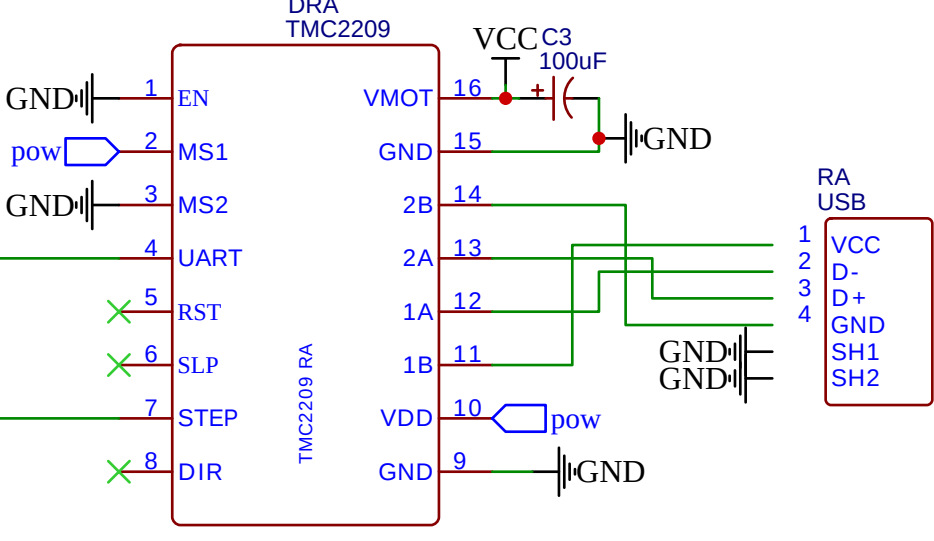
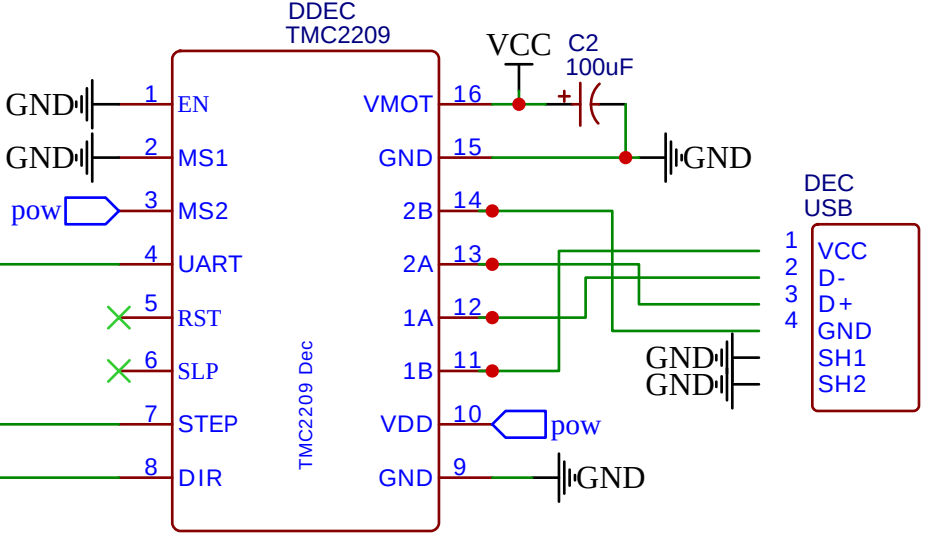
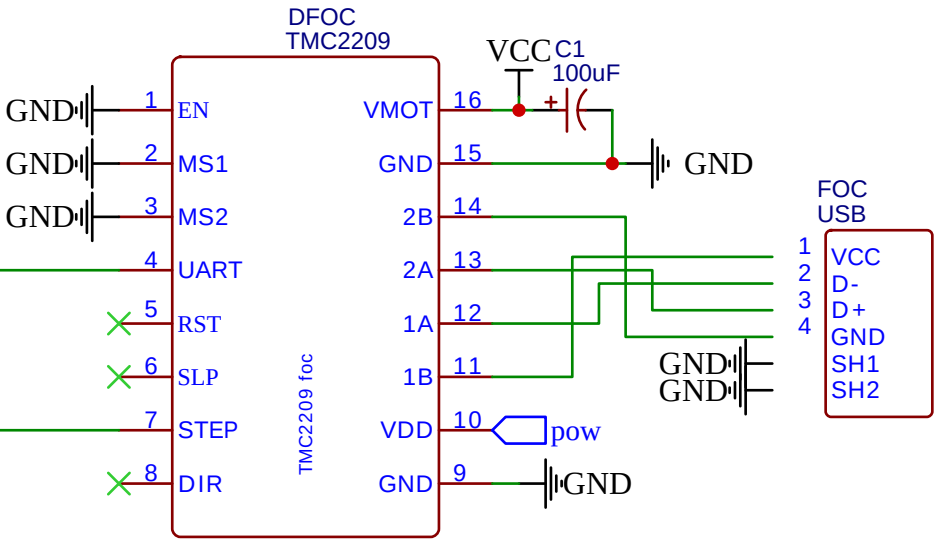
Pin9 HAS to be low, so I bridge R5 on pin21 and cut pin 9 from chip

Pin2 has a 10k pull up. so I had to remove r1 and change the values of R2 to 1.5 and R3 to 750
